RE: 9401 Black Farms Lane
Revised Grading and Drainage Plan for Swimming Pool
Engineer's Stamp Date: 04/14/21
Hydrology File: C13D027C

Based upon the information provided in your submittal received 04/14/2021, the Revised Grading and Drainage Plan for Swimming Pool is approved for Grading Permit, Building Permit, and Pool Permit.

ENGINEER'S SEAL 4/14/21 12/27/17 DAVID SOULE P.E. #14522	9401 BLACK FARM LN, N.W.	DRAWN BY WCVJ DATE 12-27-17 21811-LAYOUT-10-16-17
	GRADING AND DRAINAGE PLAN	SHEET #
	 1606 CENTRAL AVENUE SE SUITE 201 ALBUQUERQUE, NM 87106 (505) 872-0998	JOB # 21808

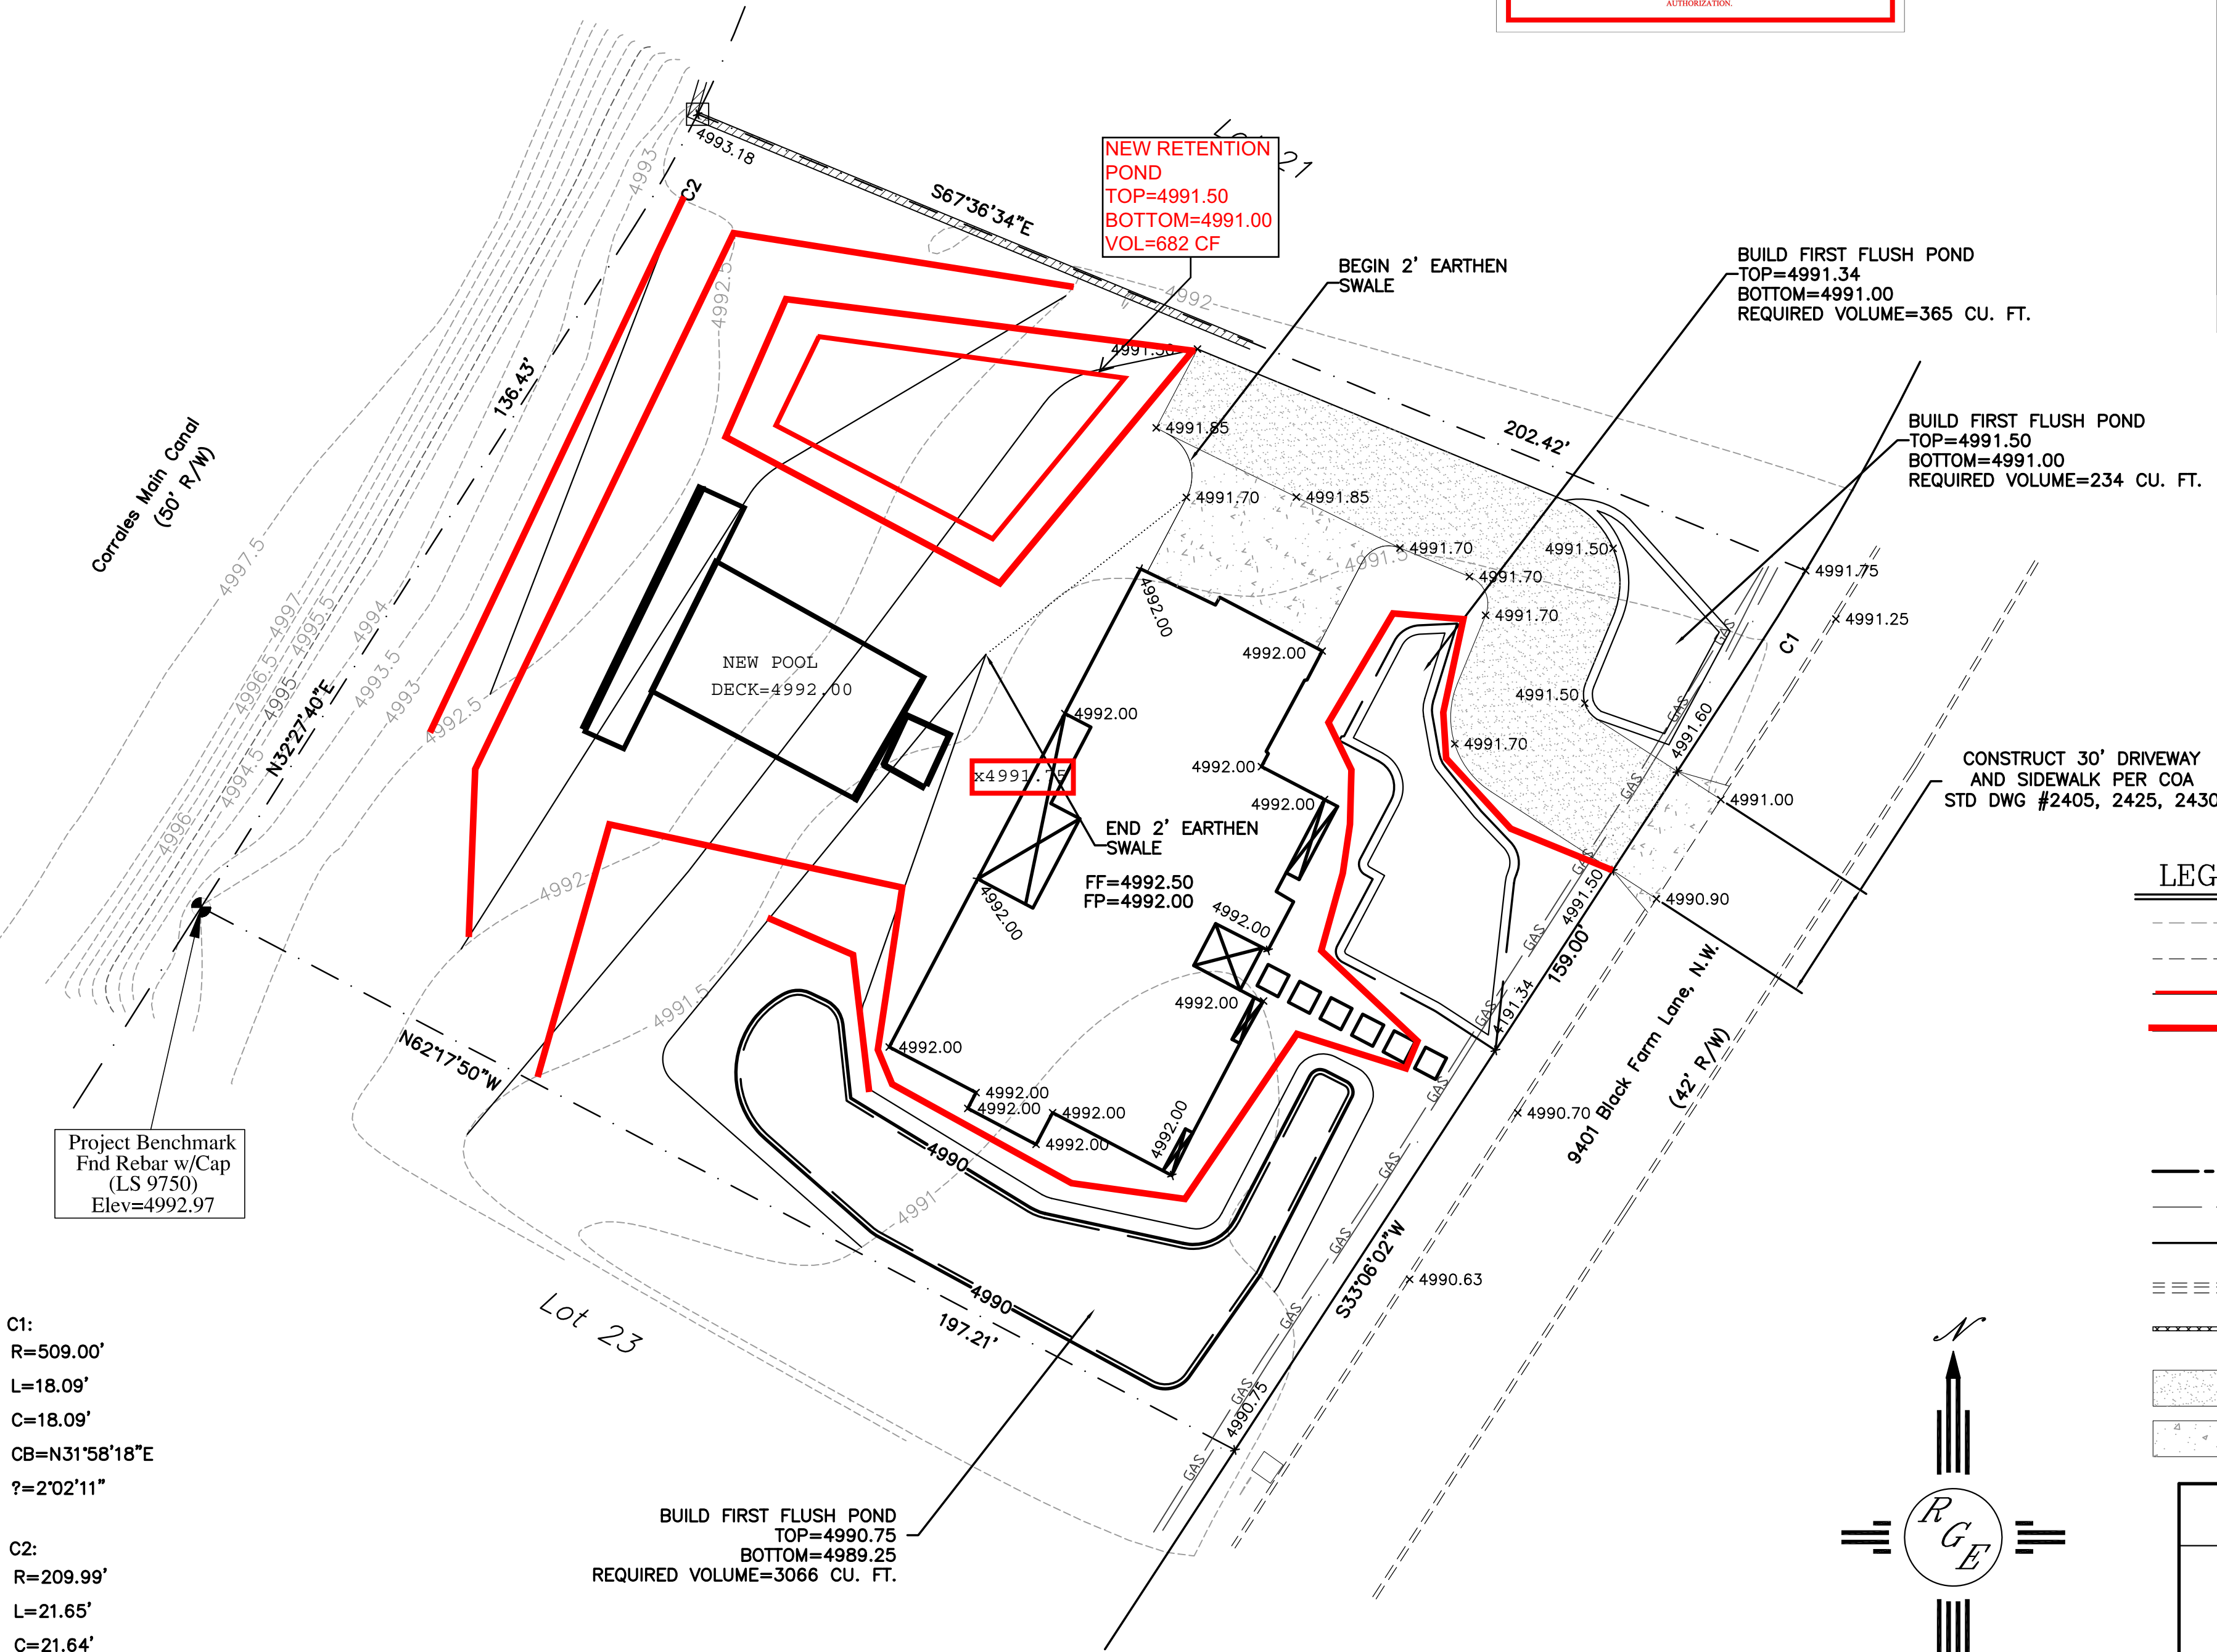
Prior to approval in support of Permanent Release of Occupancy by Hydrology, Engineer Certification per the DPM checklist will be required.
